Technical Specification Task Force Improved Standard Technical Specifications Change Traveler

Relocate Surveillance Frequencies to Licensee Control - RITSTF Initiative 5

NUREGs Affected: 1430 1431 1432 1433 1434

AC Sources - Operating
3.8.1

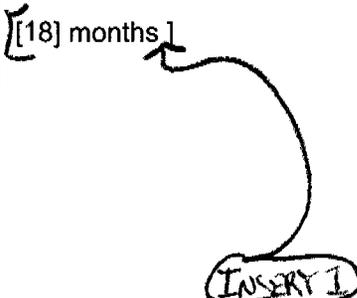
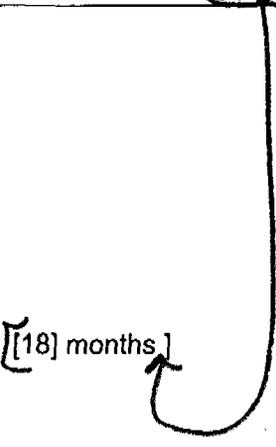
SURVEILLANCE	FREQUENCY
<p>SR 3.8.1.14</p> <p>-----NOTES-----</p> <ol style="list-style-type: none"> 1. Momentary transients outside the load and power factor ranges do not invalidate this test. 2. This Surveillance shall not normally be performed in MODE 1 or 2. However, this Surveillance may be performed to reestablish OPERABILITY provided an assessment determines the safety of the plant is maintained or enhanced. Credit may be taken for unplanned events that satisfy this SR. 3. If performed with DG synchronized with offsite power, it shall be performed at a power factor $\leq [0.9]$. However, if grid conditions do not permit, the power factor limit is not required to be met. Under this condition the power factor shall be maintained as close to the limit as practicable. <p>-----</p> <p>Verify each DG operates for ≥ 24 hours:</p> <ol style="list-style-type: none"> a. For $\geq [2]$ hours loaded $\geq [3100]$ kW and $\leq [3400]$ kW and b. For the remaining hours of the test loaded $\geq [2850]$ kW and $\leq [3150]$ kW. 	<p>[18] months ←</p> <p><u>INSERT 1</u></p>

(INSERT 1)

Diesel Fuel Oil, Lube Oil, and Starting Air
3.8.3SURVEILLANCE REQUIREMENTS (continued)

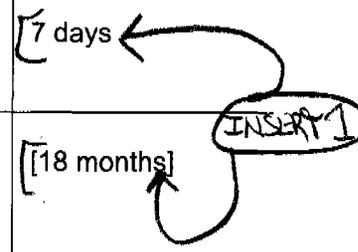
SURVEILLANCE	FREQUENCY
SR 3.8.3.5 Check for and remove accumulated water from each fuel oil storage tank.	[31] days ← <u>INSERT 1</u>

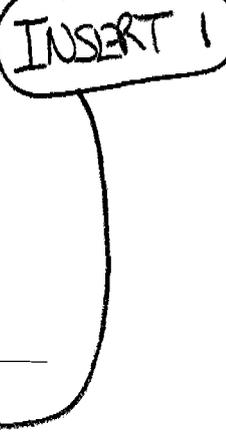
SURVEILLANCE	FREQUENCY
SR 3.3.8.2.1 -----NOTE----- Only required to be performed prior to entering MODE 2 or 3 from MODE 4, when in MODE 4 for ≥ 24 hours. ----- Perform CHANNEL FUNCTIONAL TEST.	184 days ← INSERT 1

SR 3.3.6.5.1

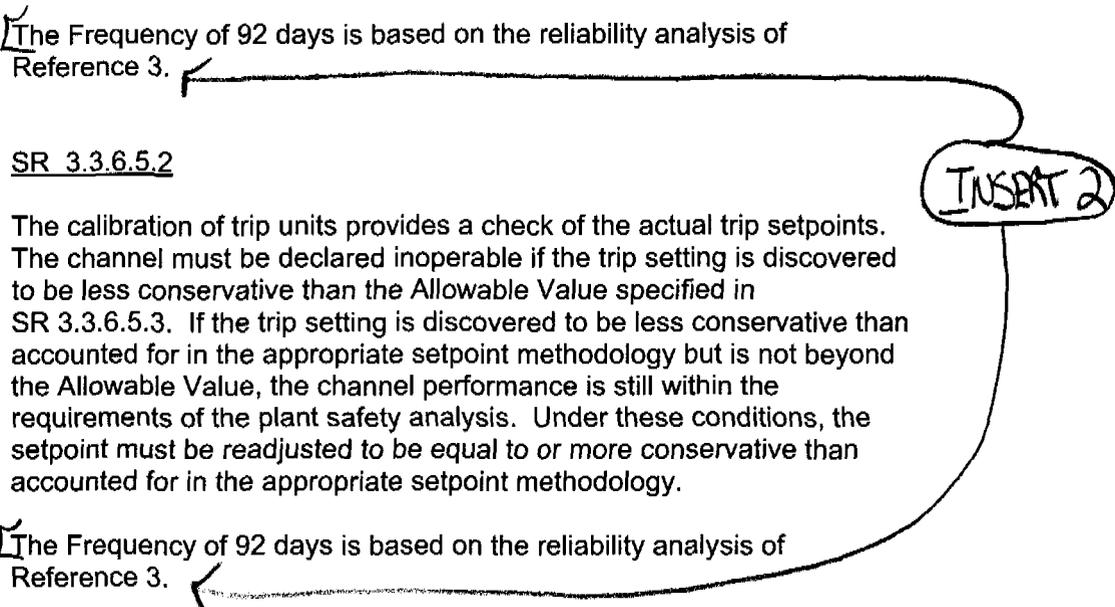
The Frequency of 92 days is based on the reliability analysis of Reference 3.
